Subject: Virgil C. Summer Nuclear Station (VCSNS) Units 2 and 3 Combined License Application (COLA) - Docket Numbers 52-027 and 52-028 Response to NRC Request for Additional Information (RAI) Letter No. 012

Reference: Letter from Manny Comar (NRC) to Alfred M. Paglia (SCE&G), Request for Additional Information Letter No. 012 Related to SRP Section 17.5 for the Virgil C. Summer Nuclear Station Units 2 and 3 Combined License Application, dated December 31, 2008.

**NRC RAI Letter No. 012 Dated December 31, 2008**

**SRP Section: 17.5 – Quality Assurance Program Description**

Figure II.1-1 SCE&G Organization

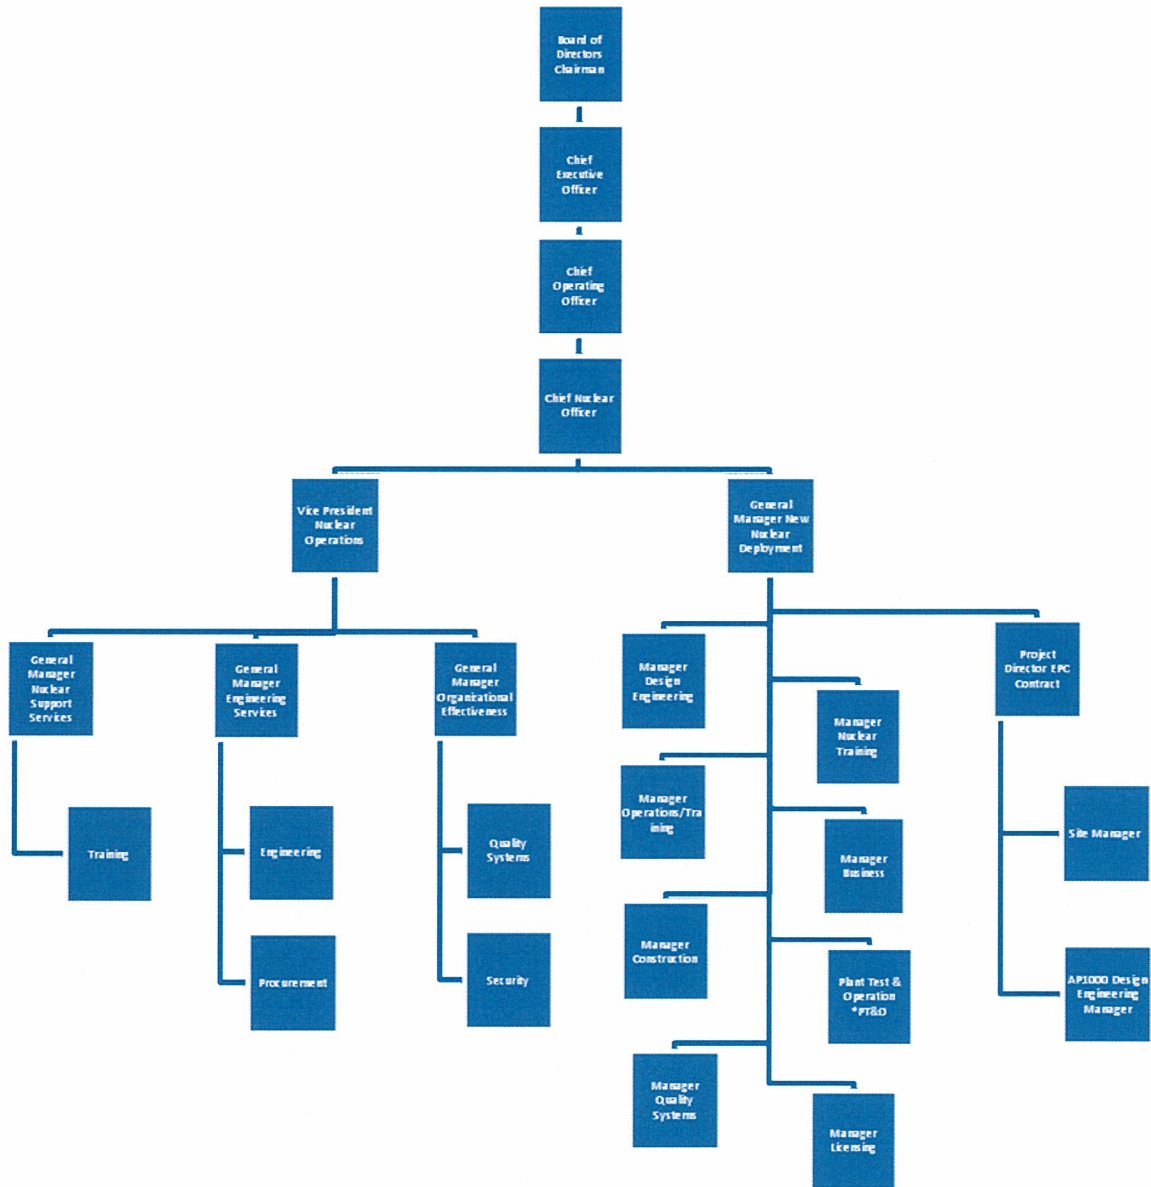
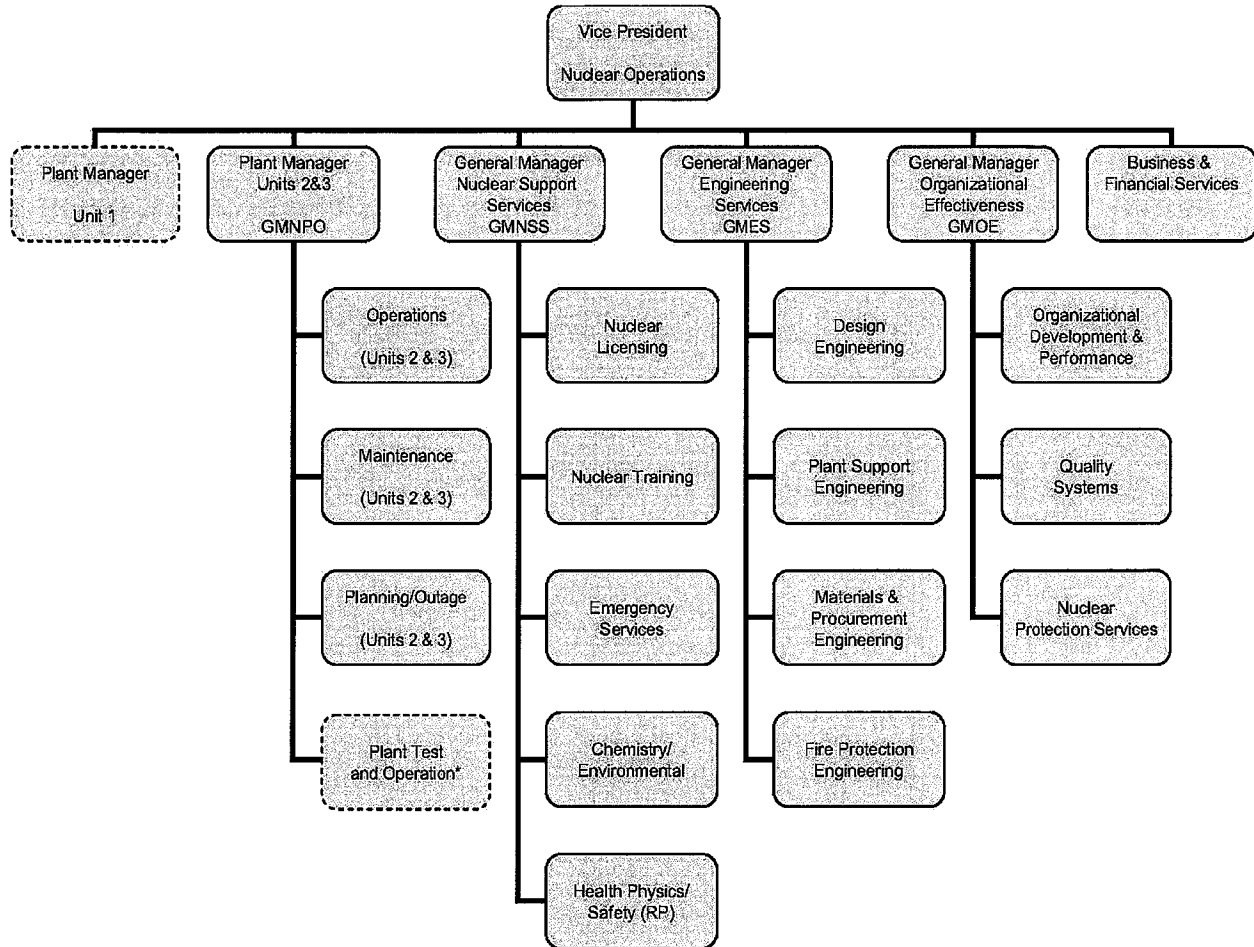
Part II, QAPD Details, Section 1 Organization states, in part, that SCE&G's New Nuclear Deployment (NND) organization is described in the QAPD. Appendix B to 10 CFR Part 50 states, in part, that every applicant for a combined license under 10 CFR part 52 is required by the provisions of section 10 CFR 52.79 to include in its FSAR, a description of the quality assurance applied to the design, and to be applied to the fabrication, construction, and testing of SSCs of the facility and to the managerial and administrative controls to be used to assure safe operation. Please provide the QAPD's description of the managerial organization for operations, including the functions of the following positions that are referred to in Section I, Section 2.6, and Section 2.7: President & Chief Operating Officer (SCE&G), NND Business and Financial Manager, Accounting Manager, Operational Quality Assurance Manager, Site Vice President, and Plant Manager. For additional guidance, please refer to TVA letter dated June 26, 2008 (BLN RAI ID: 341).

2. Replace Figure II.1-1 in its entirety with the following:

3. Replace Figure II.1-2 with the following:
